Access Compliance Report

Public Rights-of-Way

(Curb Ramps)

Intersection ID: 49346	Main Street: BLUE_JUNCTION_RD	Cross Street: FIRESPIKE_RD	Location: SW
ADA ID: AC9D2447DB9F	Ramp Type: BlendTrans1	Initial Pass/Fail: Fail	Overall Compliance: No
Severity Score: 10			
Codes/Mitigation Info/Possible Solution		Field Measurements/Component Compliance

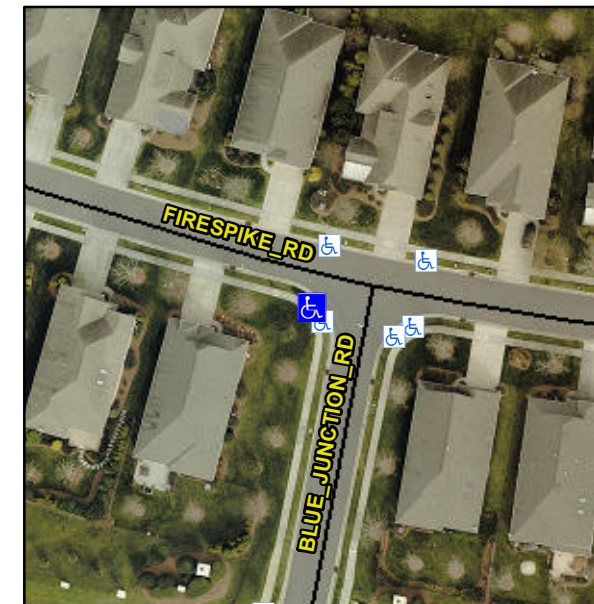
MISSING LNDG SECTION

Not Found, R304.5.1, R304.5.3

Remove & Replace Curb Ramp With Two New Directional Ramps or Equivalent.
